**Re: Response to Comments TR-01 Second Adequacy Review
City of Greeley's 25th Ave Site (Poudre Ponds); File No. M-2002-020**

POUDRE PONDS SCOUR PROTECTION PROJECT

GROUTED RIPRAP SPILLWAY DETAIL

DWN BY DJW	CHK'D ZSB	APP'D PAKM	DWG DATE 6/6/18
		SCALE	
PROJECT NO. COC0G105		SHEET NO. C-501	
		REV NO.

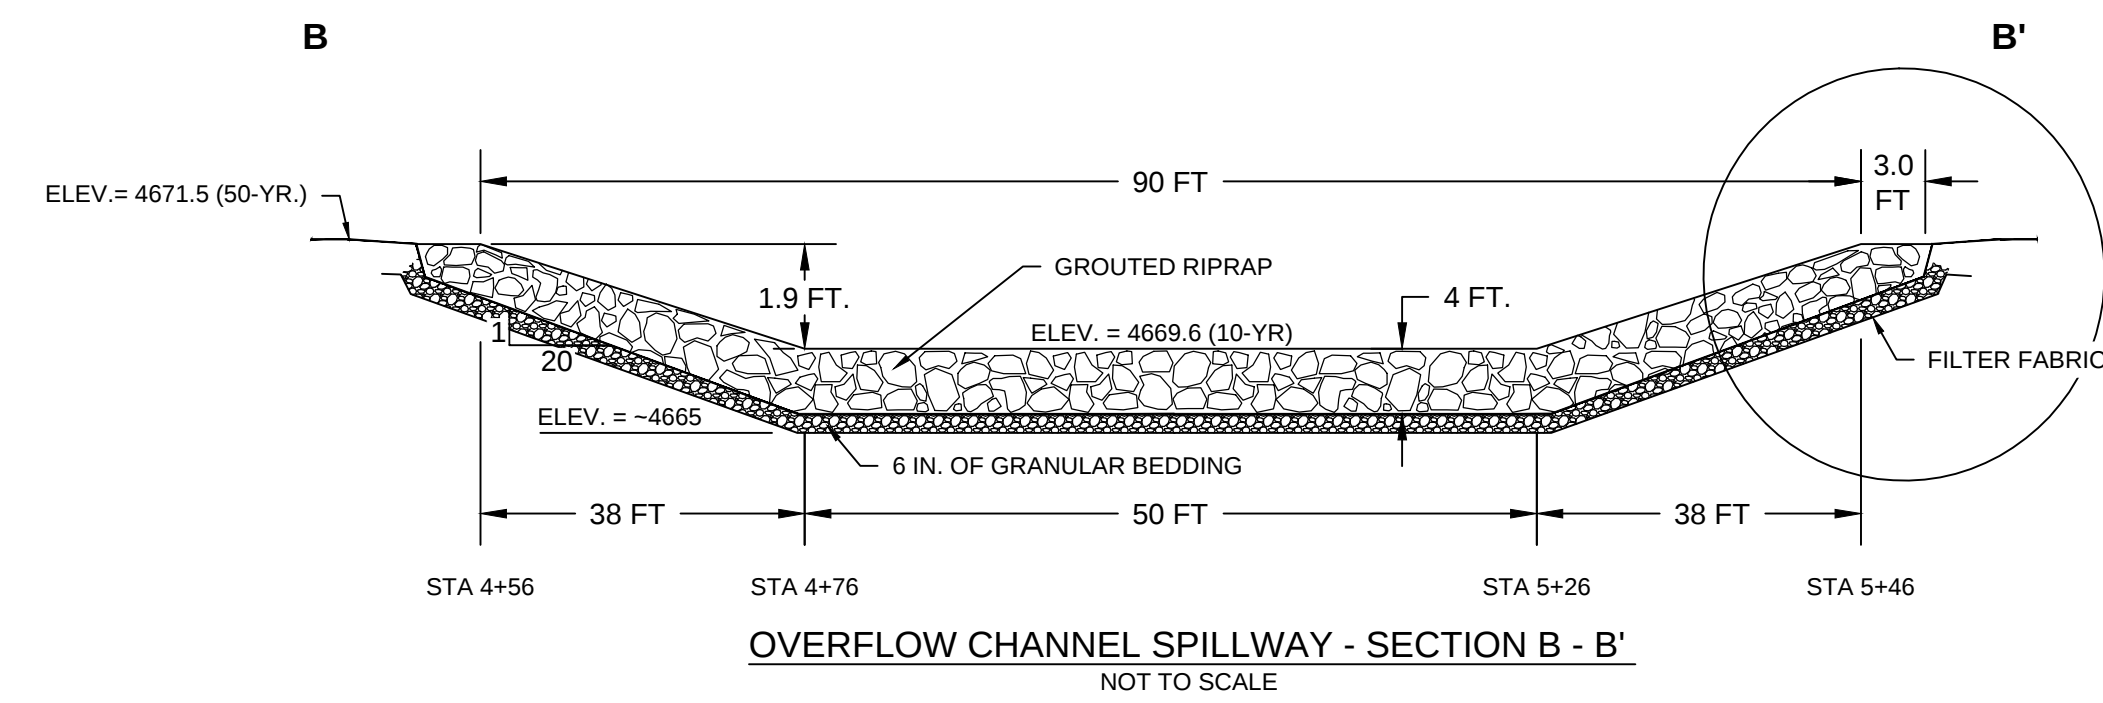
Comment 1d: *P. 4, second bullet, design standards: the third line cites UDFCD’s standard of leaving the top third of grouted boulders ungrouted (to provide roughness for energy dissipation). However, Sheet No. C-501, Grouted Riprap Detail shows only the top 25% of the grouted riprap layer (4 ft minus 3 ft) being ungrouted. This same detail shows multiple boulders in the “layer” of grouted riprap. Pursuant to Figure 9-15 of the UDFCD manual (Vol. 2) referenced on p. 6, third paragraph of this submittal (and Figure 2.7 of the also referenced CWCB’s Floodplain and Stormwater Criteria Manual), the grouted riprap armoring should be a single layer of boulders grouted to within one third of the top of the rock. This is not how the design is depicted in this detail on Sheet No. C-501 and is critical in demonstrating to the construction contractor how the spillway is to be constructed. Please revise the appropriate drawing to meet the design standard.*

Comment 3b: *P. 6, third paragraph, drawing reference: The last sentence references "concrete cutoffs" for the design. Sheet No. C-501 Section A-A' and Key In/Anchor Detail both show a shaded rectangle where one would expect the cutoff wall, but it is not labeled. Please show and label as such the concrete cutoff wall on the appropriate drawing.*

Sheet C-501 has been updated to more clearly reflect the $d_{50} = 24$ in chosen rock size with the associated gradation. The depth of top of grout from rock surface is specified as $1/3$ of the d_{50} dimension. The total thickness of 4 ft is twice the d_{50} dimension to accommodate the chosen gradation.

Sheet C-501 has been updated to further identify the concrete cutoff.
